SUBJECT: ROGERO ROAD ROUNDABOUT

CITY OF JACKSONVILLE
DEPARTMENT OF PUBLIC WORKS
ENGINEERING DIVISION
CONSTRUCTION CHANGE ORDER

Change Order No. One (1) Date May 19, 2020

Description of Project Rogero Road Roundabout

UTILITY ADJUSTMENT PLAN

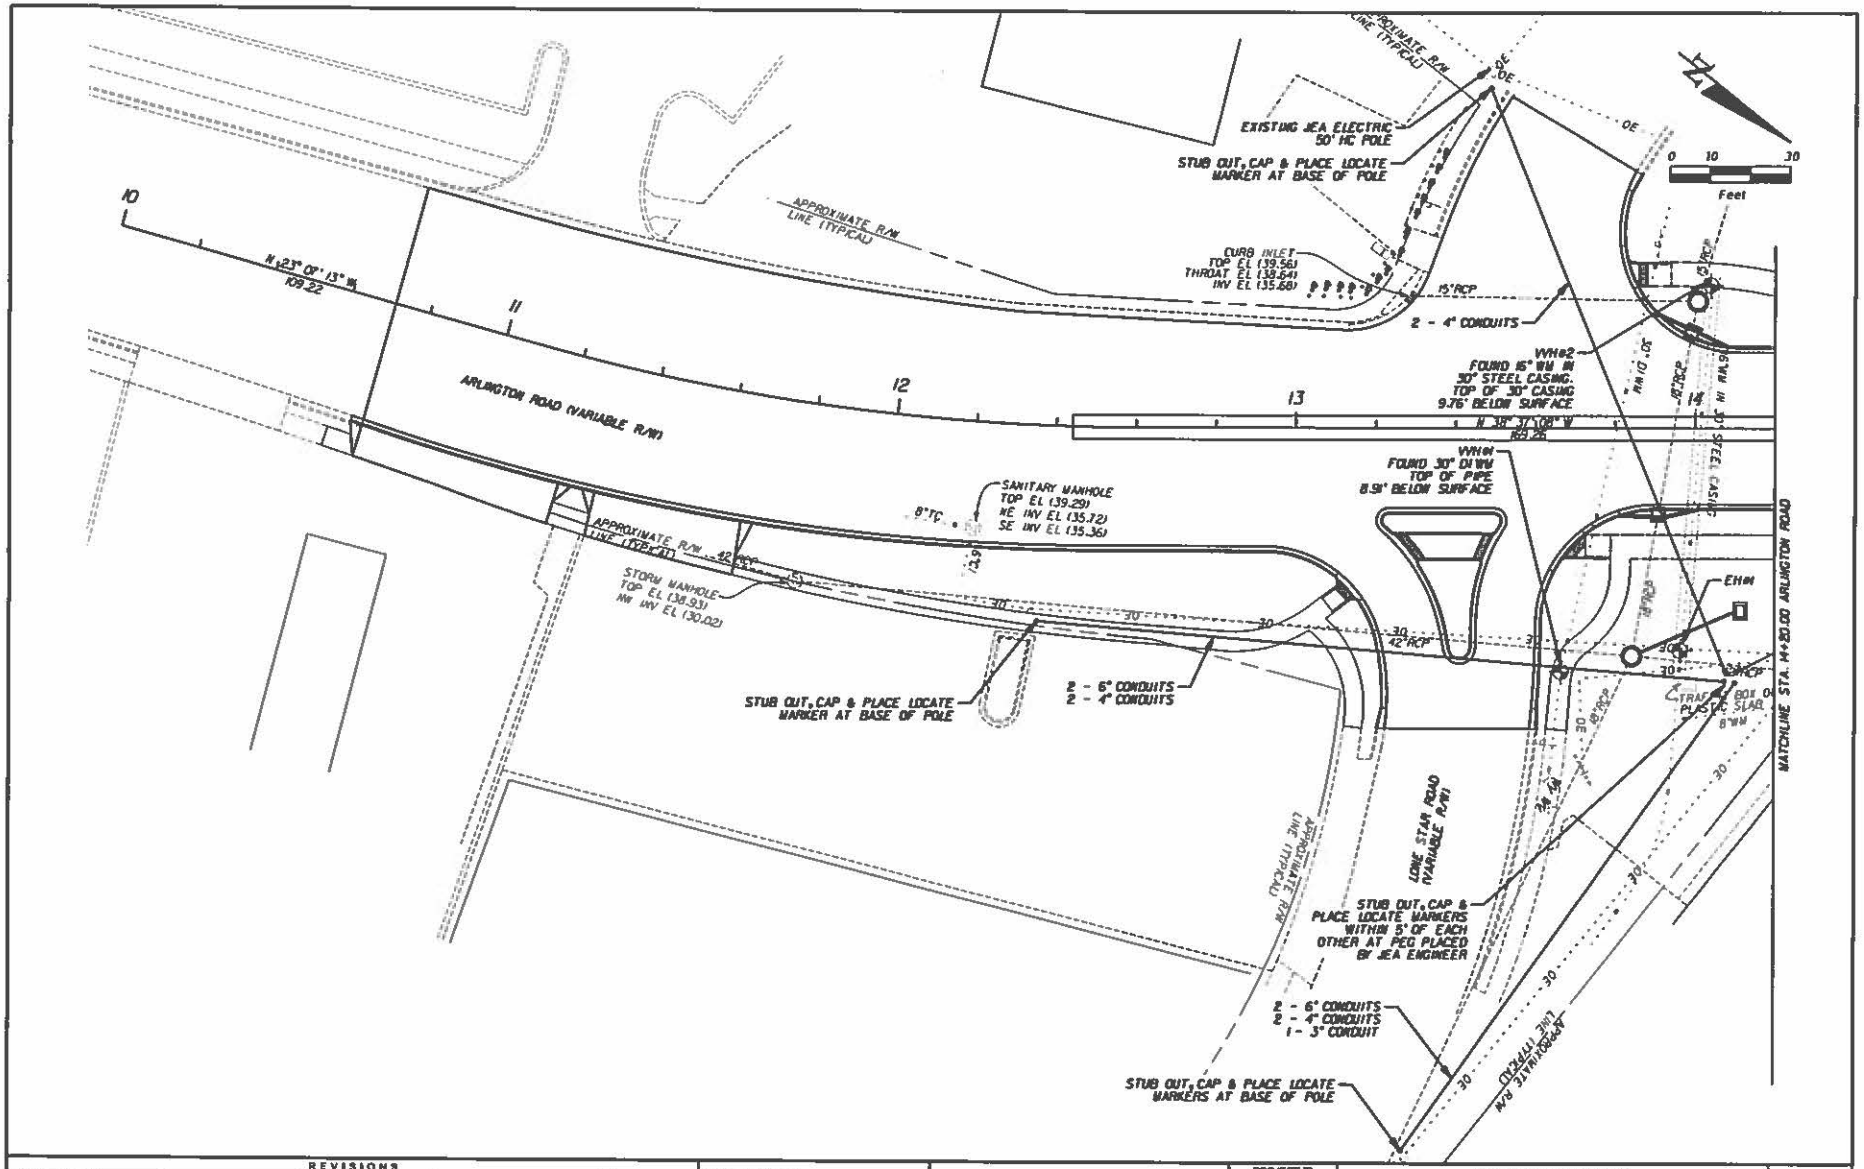
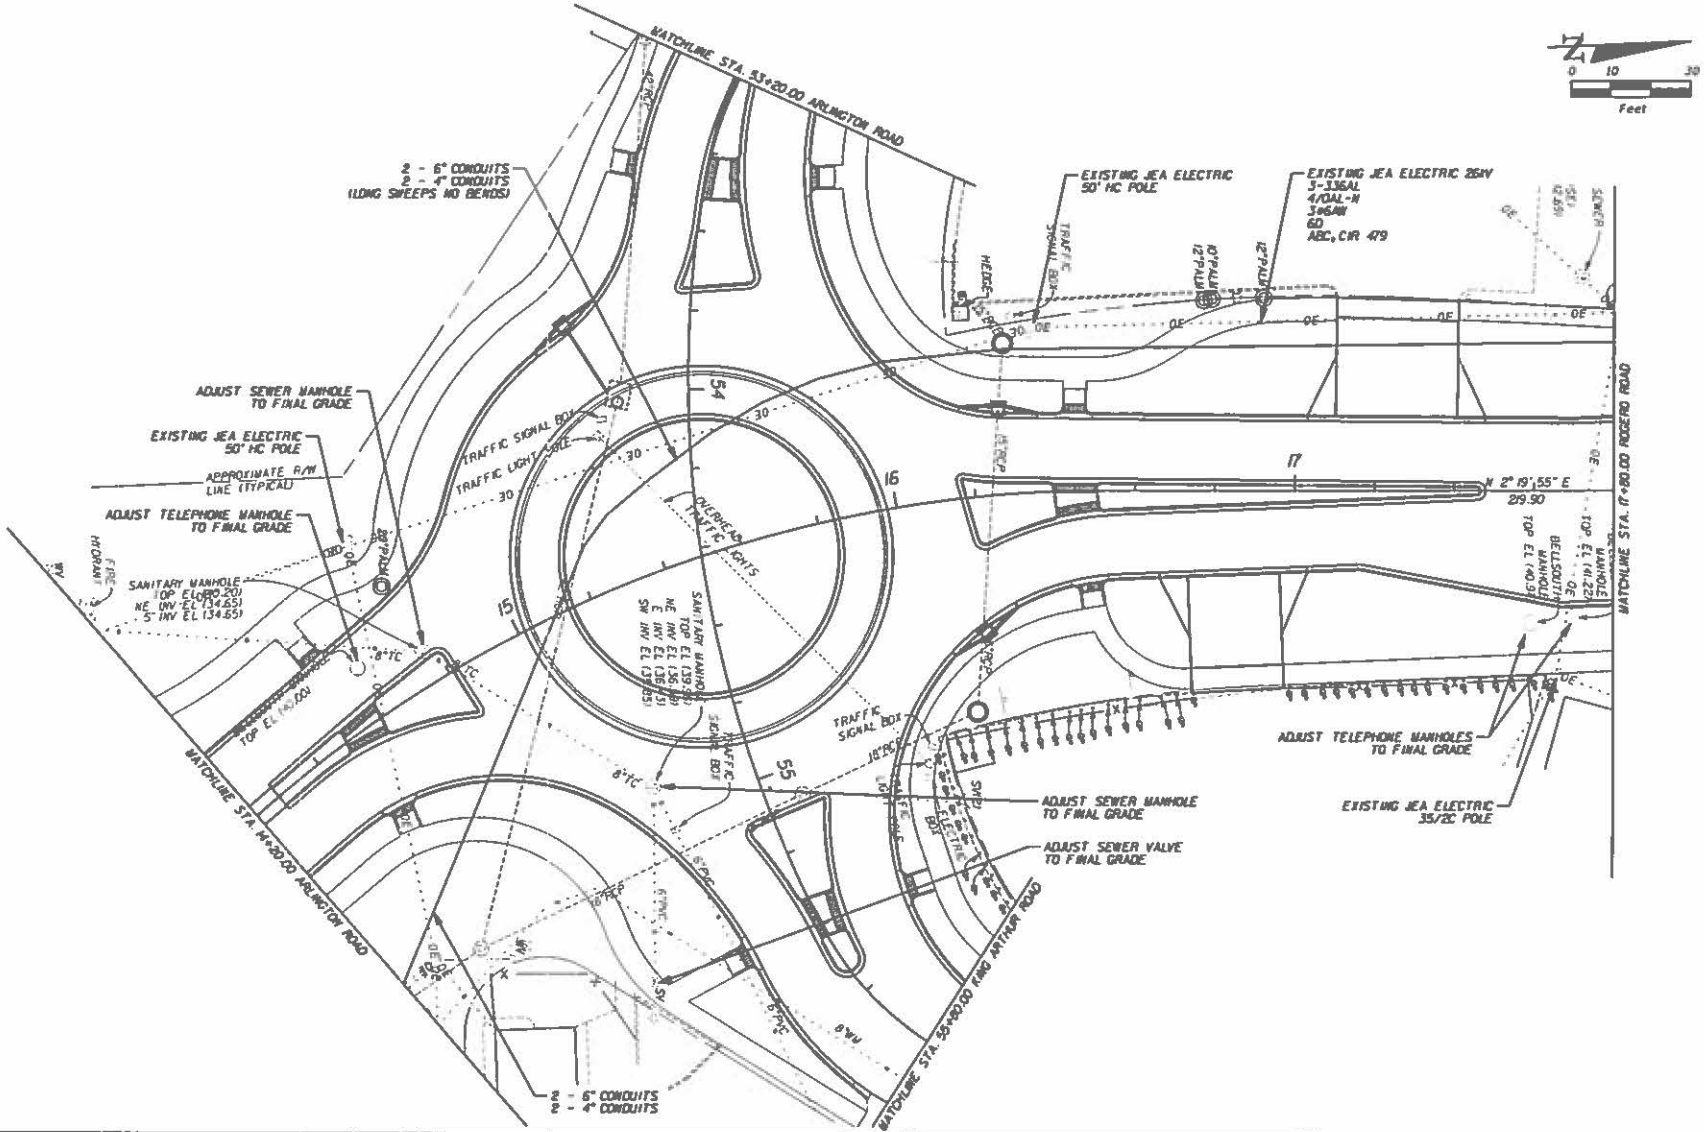
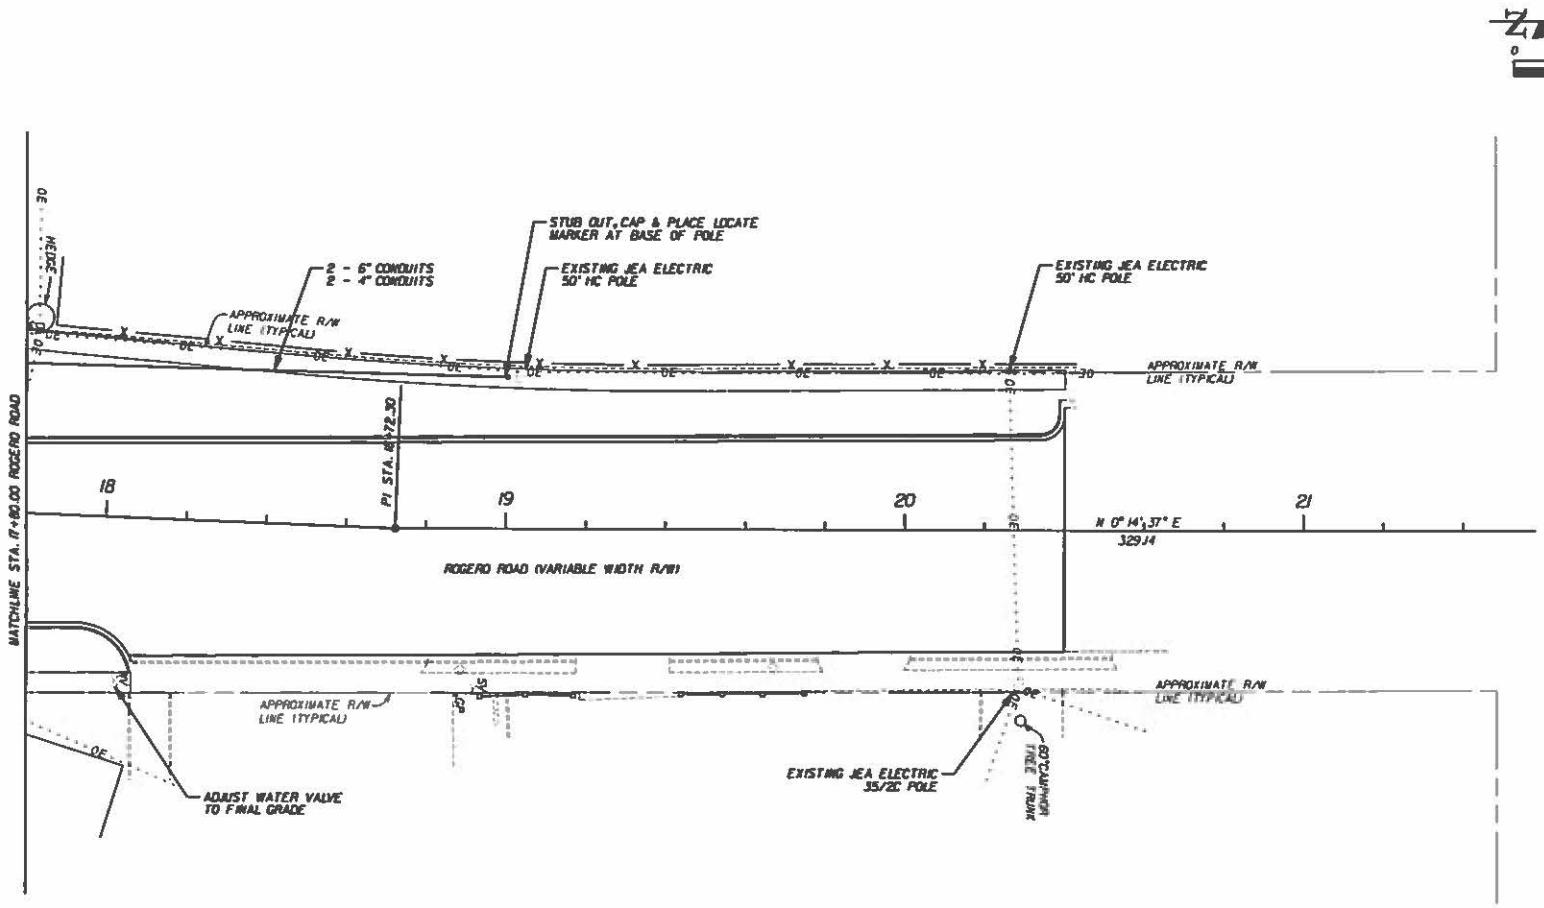
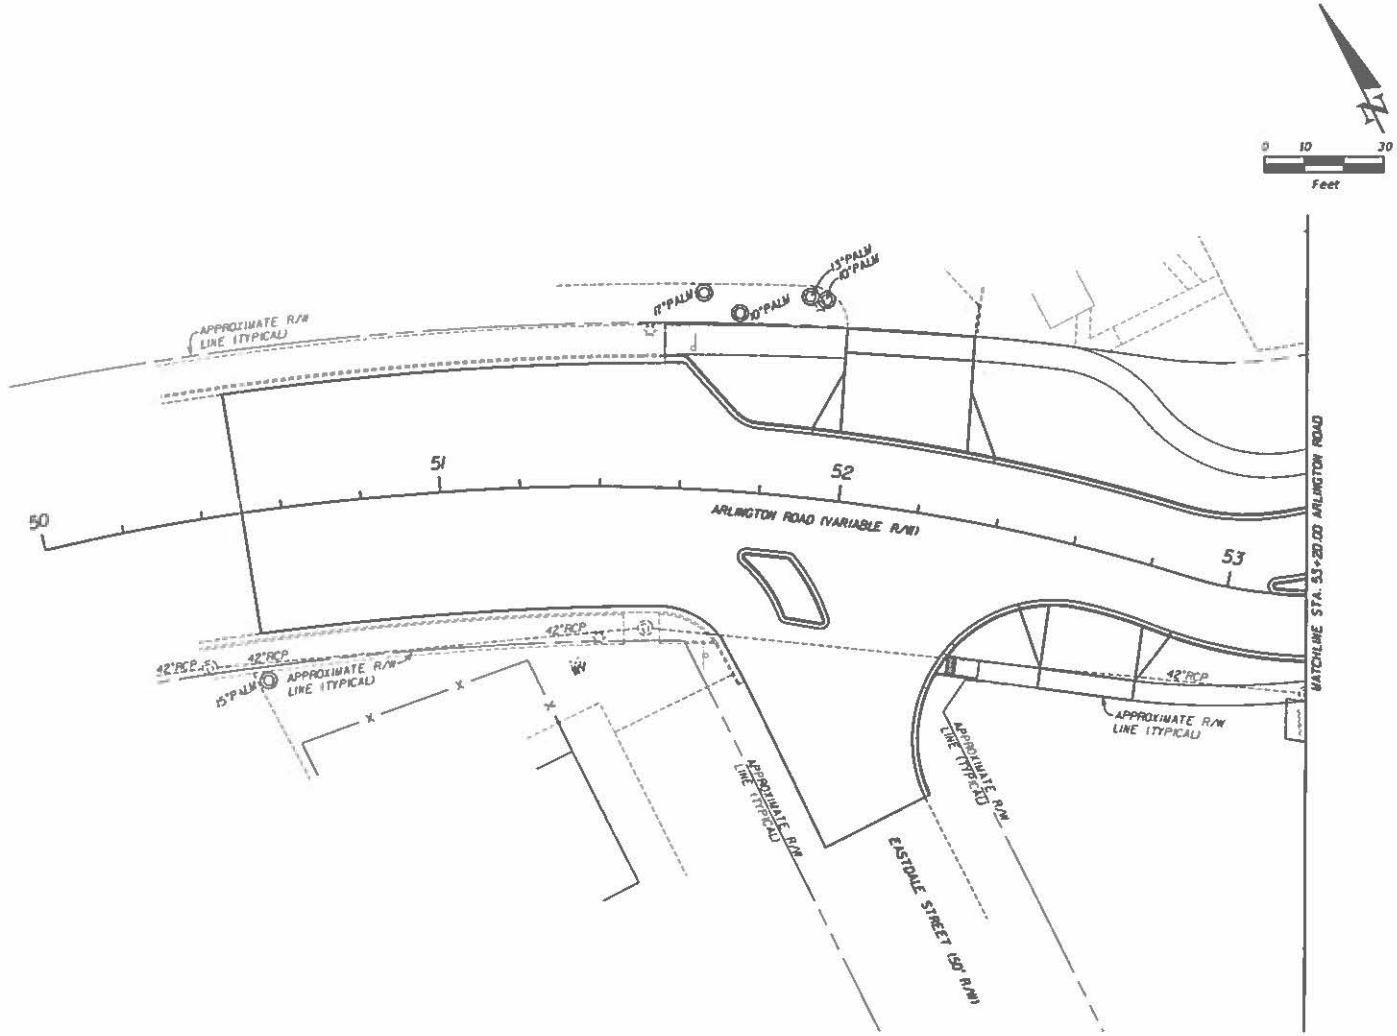
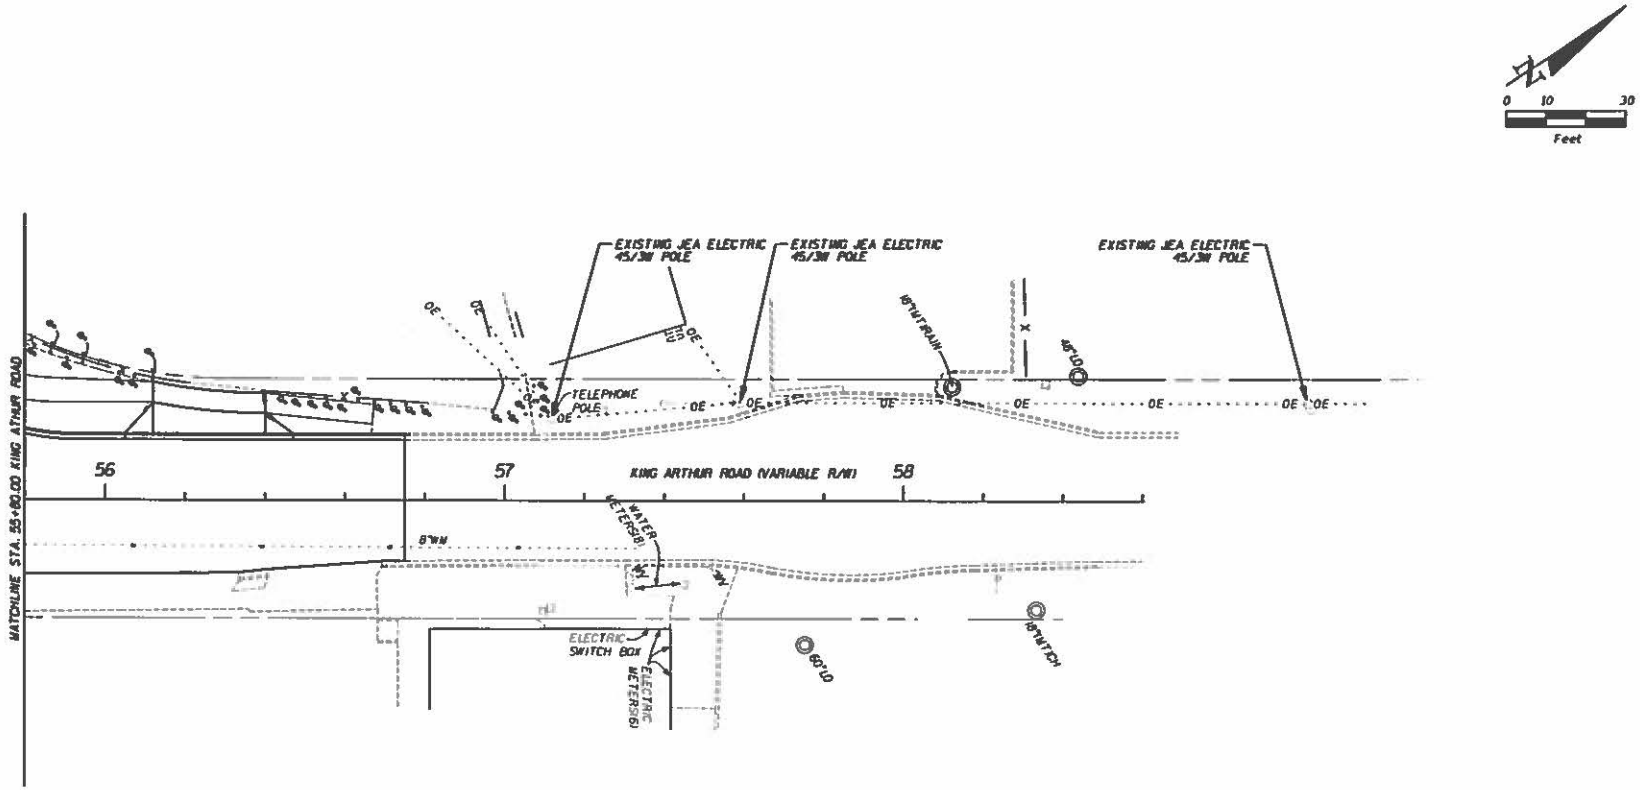
NBR	MASTER ITEM DESCRIPTION	QUANTITY	UOM	UNIT COST	NET ADDITION	NET DELETION	NET TOTALS
	ADDITIONAL SCOPE						
1	JEA CONDUIT	1.00	LS	$93,448.04	$93,448.04		
	JUSTIFICATION: PCO 1 - Includes cost associated with the installation of directional bore 3-4" and 2-6" conduits and associated MOT, excavation, and other misc. work. COJ requrested work to be done post bid. PCO 1 adds 30 calendar days to contract time if needed.						
2	Replacement of Deteriorated existing pipe	1.00	LS	$5,400.00	$5,400.00		
	JUSTIFICATION: PCO 2 - upon removal of existing asphalt it was determined that one run of existing pipe that was to remain in place had deteriorated. This cost is to replace 24 LF of pipe with connection to existing structure and connection to remaining pipe. PCO No. 2 adds zero calendar days to contract time.						
	TOTAL ADDITIONAL SCOPE				$98,848.04	$0.00	
	NET TOTAL ADDITIONAL SCOPE						**$98,848.04**

Description:
In response the utility design revision dated March 20th, 2020; enclosed you will find pricing to include qualified supervision, labor, material, equipment and tool to install the additional conduit represented in the design revision. Due to the substantial nature of the design change, 30 additional days of contract time is requested.

DESCRIPTION OF ADDITIONAL WORK OR CHANGED LOCATION: City of Jacksonville issued design revision, Revised Utility Plan, 3.20.20. The pricing herein encompass the HDD installation of the conduits depicted i the design revision.
